**JOINT REGIONAL PLANNING PANEL  
Sydney West Region**

<b>JRPP No</b>	<b>2009SYW007</b>
<b>DA Number</b>	<b>DA0410/09</b>
<b>Local Government Area</b>	<b>Ku-ring-gai Council</b>
<b>Proposed Development</b>	Demolition of four existing dwellings and construction of two residential flat buildings comprising 62 units including basement car parking, front fence and landscaping.
<b>Street Address</b>	27 – 33 Boundary Street, Roseville
<b>Applicant/Owner</b>	Hyecorp Property Fund No. 6 Pty Ltd
<b>Number of Submissions</b>	18
<b>Recommendation</b>	<b>Refusal</b>
<b>Report by</b>	<b>Ku-ring-gai Council Staff</b>

**SUMMARY SHEET**

To determine Development Application No.0410/09, following the Land and Environment Court's decision in Ku-ring-gai Council v Sydney West Joint Regional Planning Panel (No 2) [2010] NSWLEC 270 which made void the decision to approve the application by the Joint Regional Planning Panel on 31 January 2011.

Figure 1 privacy relationship between 25 Boundary Street and proposal

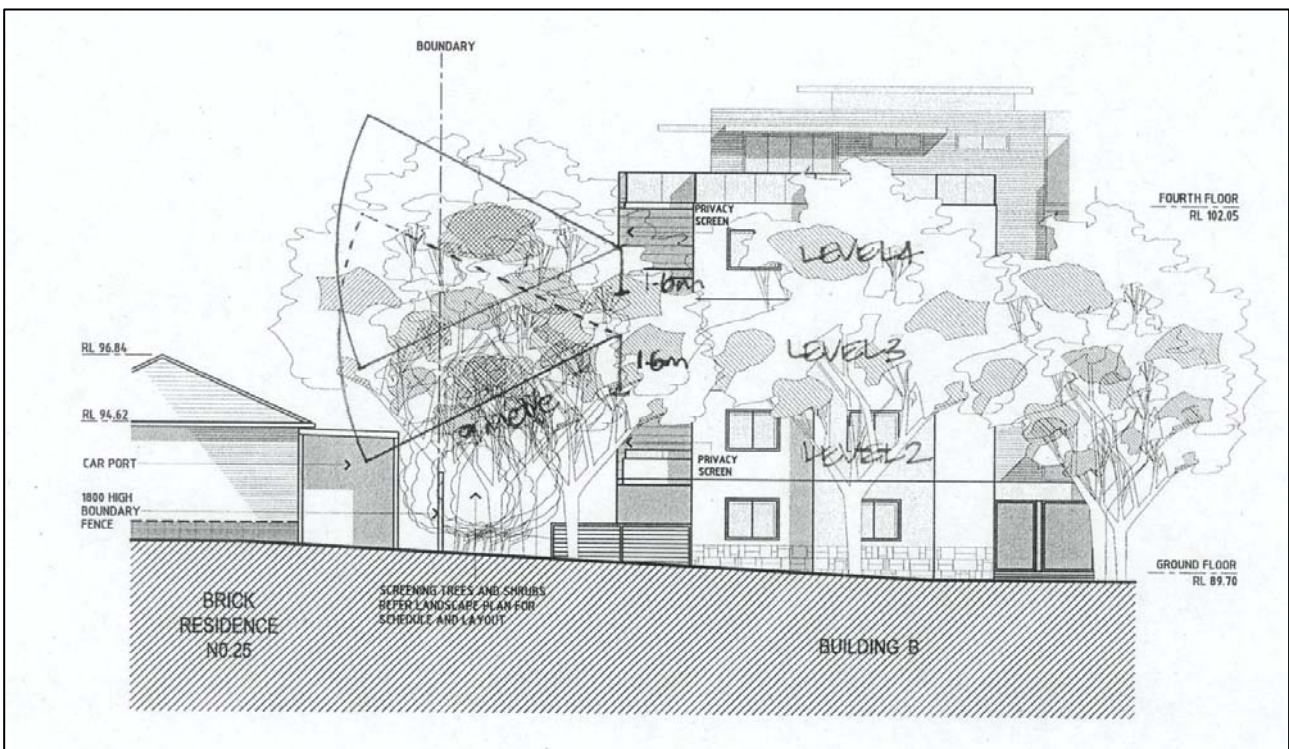
The dwelling at 25 Boundary Street adjoins the south-western corner of Building B. The siting of the existing dwelling adjoins the location of two bedrooms associated within units 2, 9, 16 and 23 and the balcony associated with Units 1, 8, 15 and 22. There is no concern regarding the bedrooms, given the low intensity usage of these rooms. **Figure 1** below represents the relationship between Building B and the existing dwelling at 25 Boundary Street. A sight line has been drawn from 1.6 metres on the balcony at Levels 3 and 4 to a distance of 9 metres at 45°. This demonstrates that the balconies within the development above Level 2 will not impact on the privacy of this property.

As discussed above under the SEPP 65 assessment, the development is not considered to result in a significant loss of privacy to 25 Boundary Street. The upper levels of the development overlook the dwelling as demonstrated in **Figure 1**. The lower levels are provided with privacy screens and landscape screening within the side setback which is considered sufficient to maintain privacy.

It is considered that the provision of privacy screens at Levels 1 and 2, combined with the extensive landscaping along the western boundary will provide a reasonable level of privacy to 25 Boundary Street.

If the development were to be supported, a condition would be recommended to require the proposed planter boxes to be extended in a western direction along the northern elevation and southern direction at Level 5 and to have landscaping with a height of 1.8 metres to maintain the relationship with properties fronting Victoria Street.
